RAR: REVISE AND SUBMIT,
27/07/2023

ENERGERA		PO# 23258	SO# 231054
THIS DRAWING IS THE OF PROPERTY OF FOURSTAR RESOURCES INC. AND IS NOT TO BE PRINTED, PHOTOGRAPHED, COPIED, LOANED OR USED WITHOUT ITS PERMISSION			
FOURSTAR RESOURCES INC. NISKU, ALBERTA, CANADA		4'-2" x 14'-0 3/4" LG SKID FOR FSR750IH RH/LH MOUNT INDIRECT HEATER	
DRAWN BY: WT	DATE: JUL07/23	CHECKED BY: WT	DATE: JUL07/23
APPROVED BY: WT	DATE: JUL07/23	SCALE: AS SHOWN	DRAWING NO. 231054SKID

TOP VIEW
1. SCALE: 3/4"=1'-0"

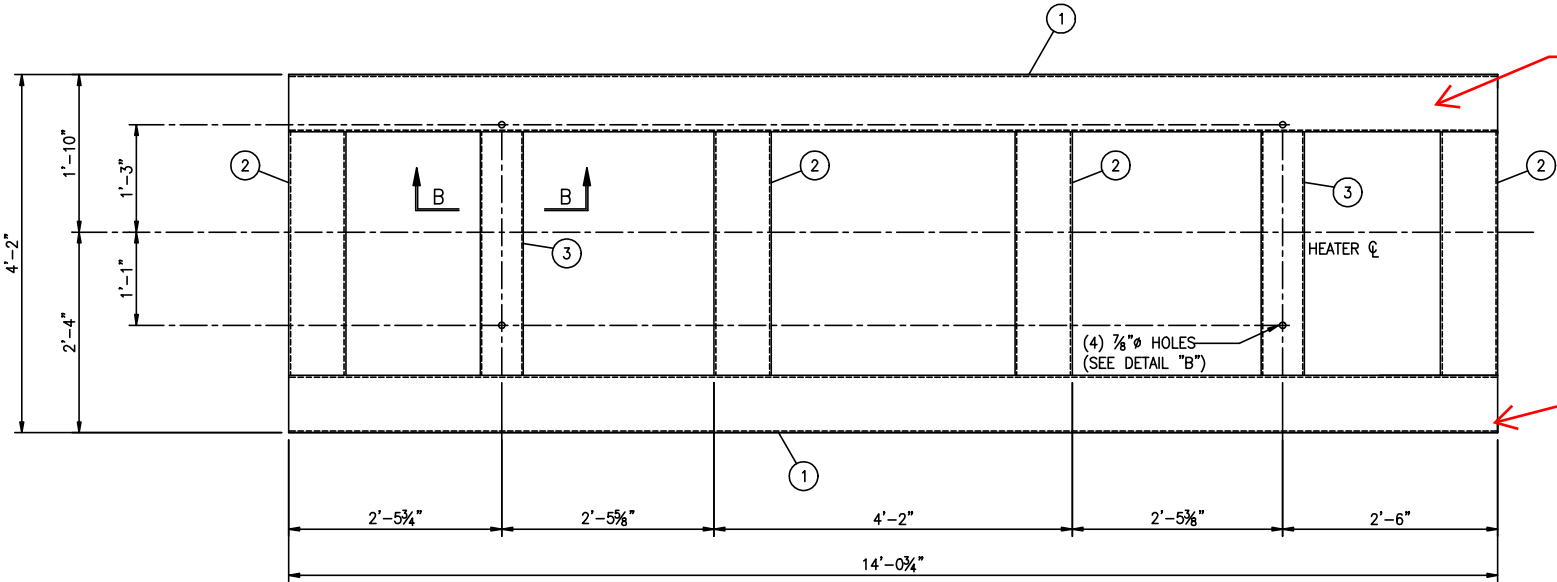
Is this your standard
skid design for 750K
heater? how is it lifted
usually ? Eventually
after project, we will
have to disassemble it
from our trailer.

Lift Lugs per quote ?
